YXPO161063(Candice)11#
材料：1.2mm镀锌钢

HSJ metal fabrication

UNLESS OTHERWISE SPECIFIED DIMENSIONS ARE IN INCHES TOLERANCES ARE: .XX +/- .01 .XXX +/- .007 DO NOT SCALE DRAWING	APPROVALS	DATE
	DRAWN MBG	CHANGE TAB WIDTH TO 0.320 /
	CHECKED JL	
	MATERIAL: Aluminum 0.062" 5052 铝 5052 0.062" 厚	
CARDINAL P141-BK03 r equivalent 黑色喷粉		SCALE 1:1
		FILE: E911_m900_bottom_revF

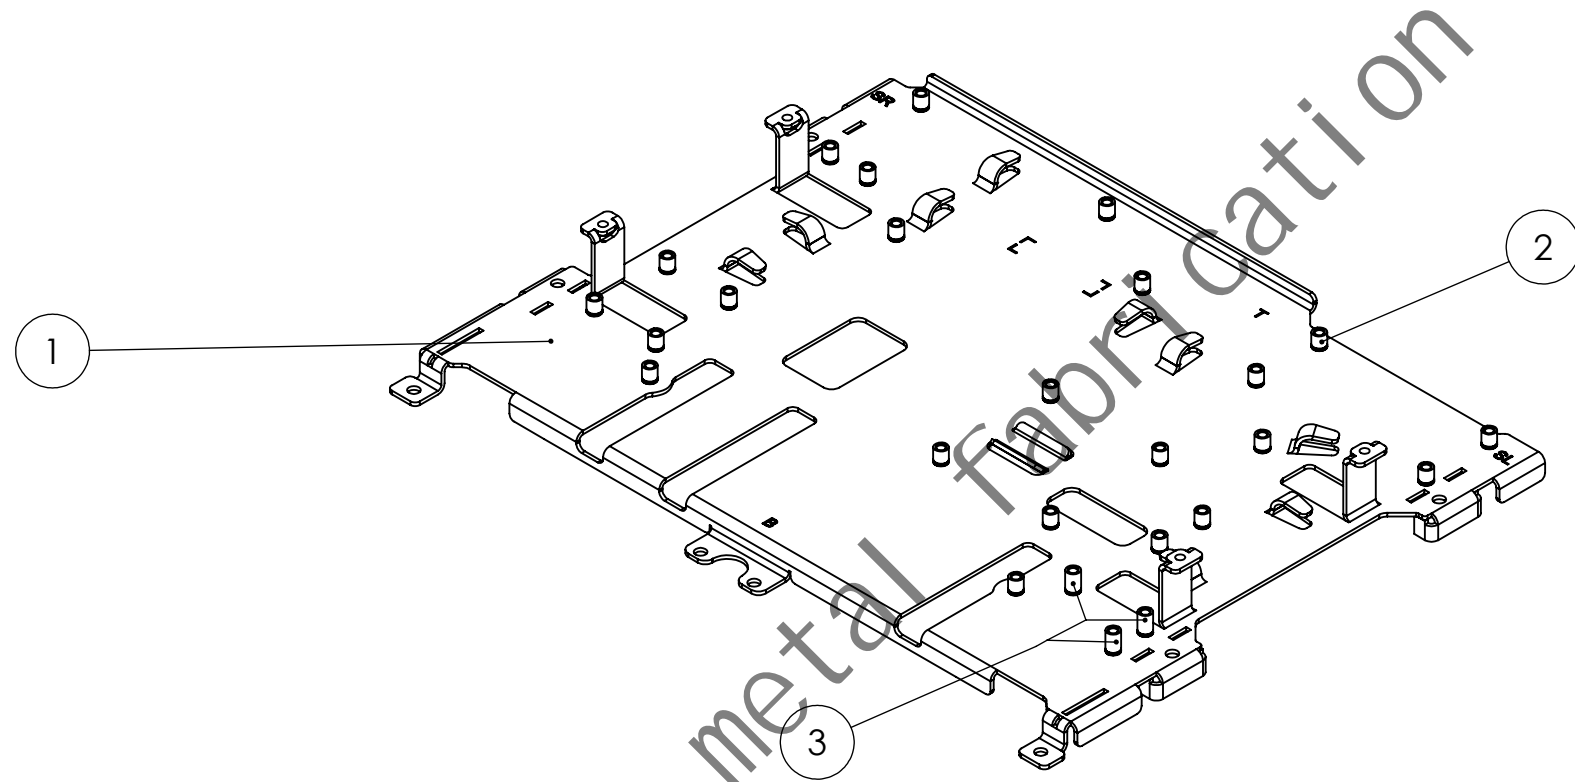
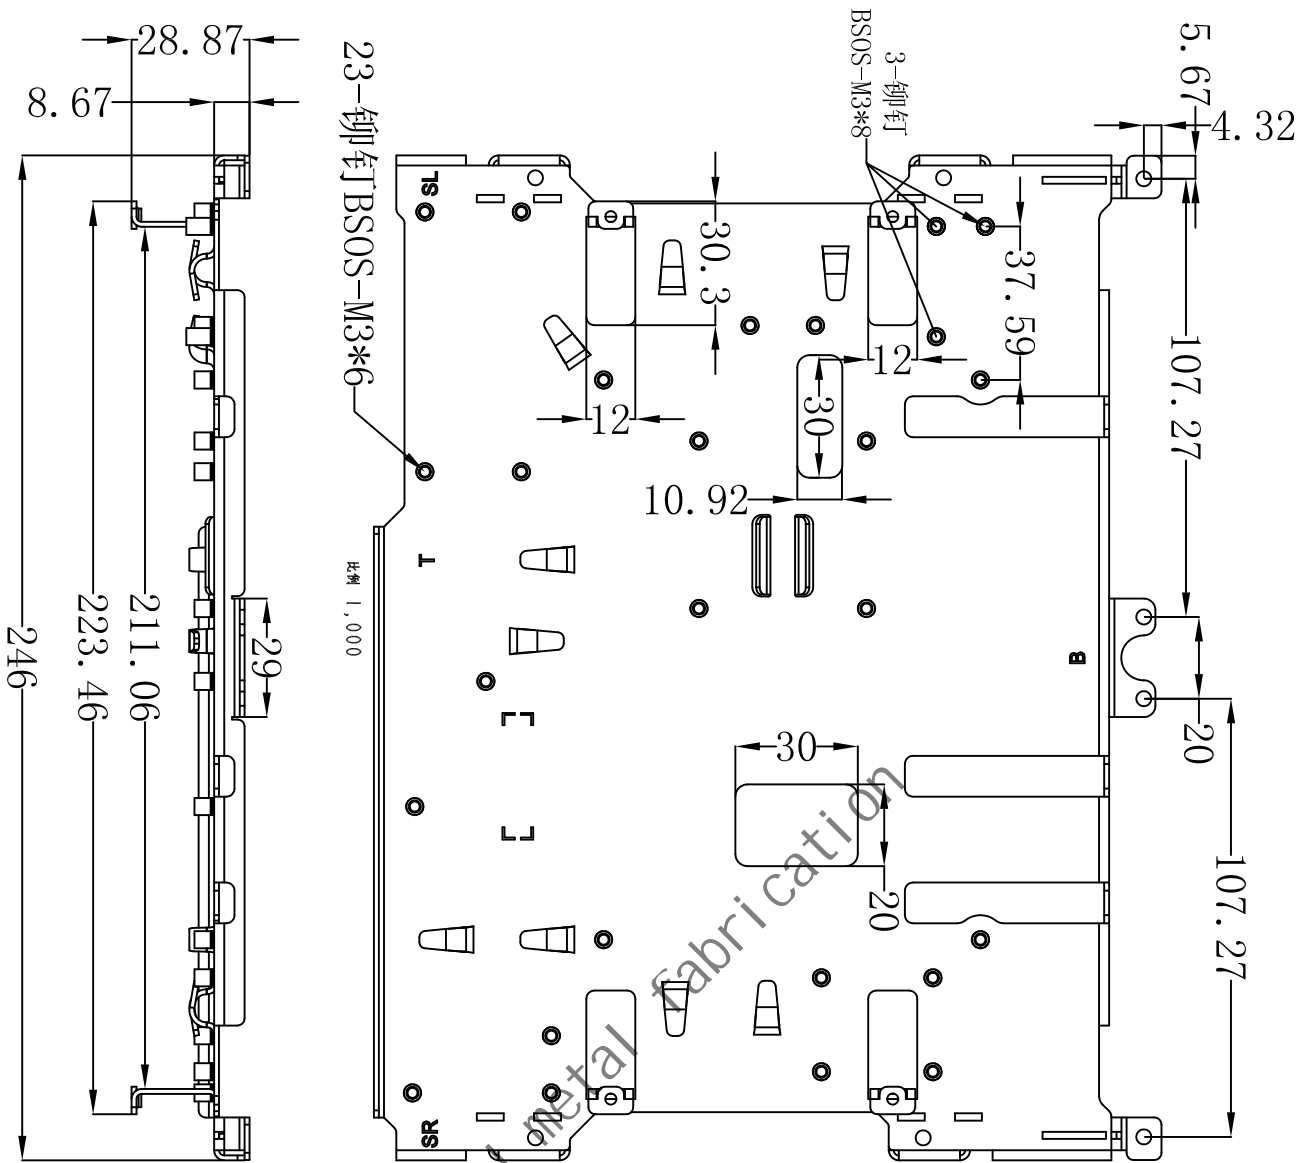
REVISIONS				
ZONE	REV.	DESCRIPTION	DATE	APPROVED
	000	INITIAL RELEASE	10-14-2015	
	001	NEW PCB MOUNT POSITIONS	03/21/2016	
	002	NEW COMPONENT TRAY DESIGN	09/28/2016

REV. F
SHEET 1 OF 1

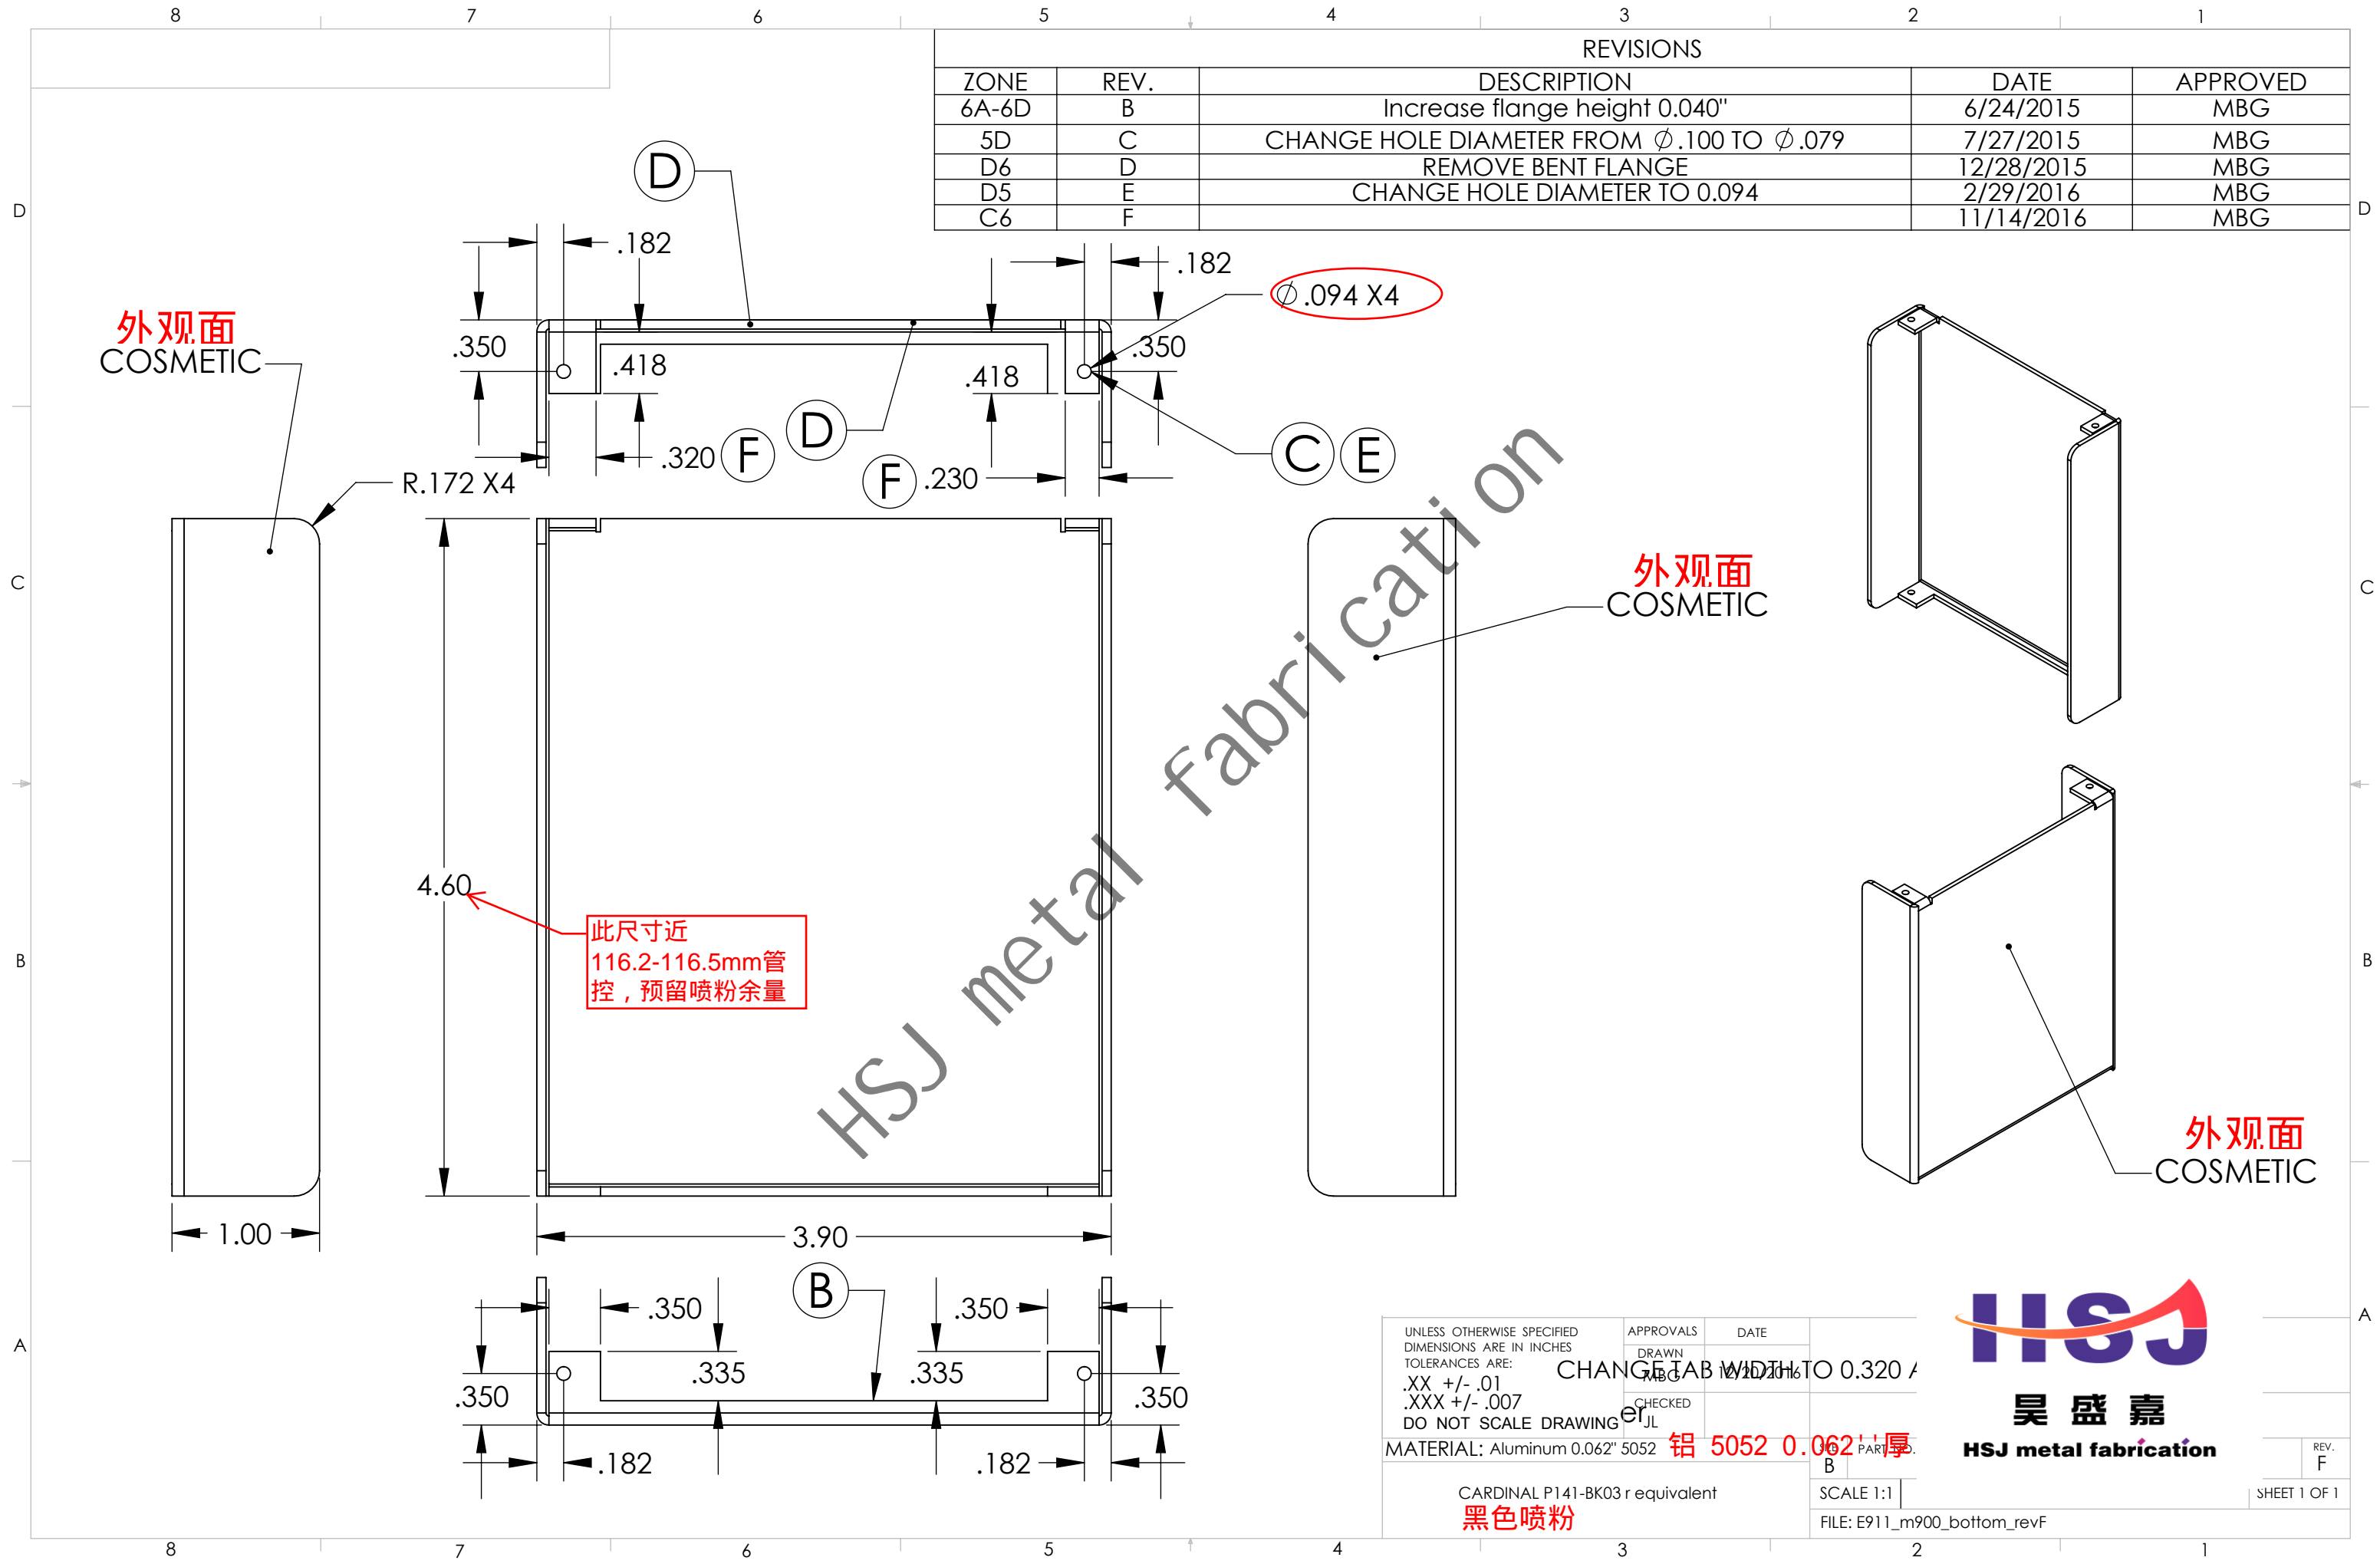
REVISIONS				
ZONE	REV.	DESCRIPTION	DATE	APPROVED
6A-6D	B	Increase flange height 0.040"	6/24/2015	MBG
5D	C	CHANGE HOLE DIAMETER FROM $\phi .100$ TO $\phi .079$	7/27/2015	MBG
D6	D	REMOVE BENT FLANGE	12/28/2015	MBG
D5	E	CHANGE HOLE DIAMETER TO 0.094	2/29/2016	MBG
C6	F		11/14/2016	MBG

此尺寸近
116.2-116.5mm
管控, 预留喷粉余量
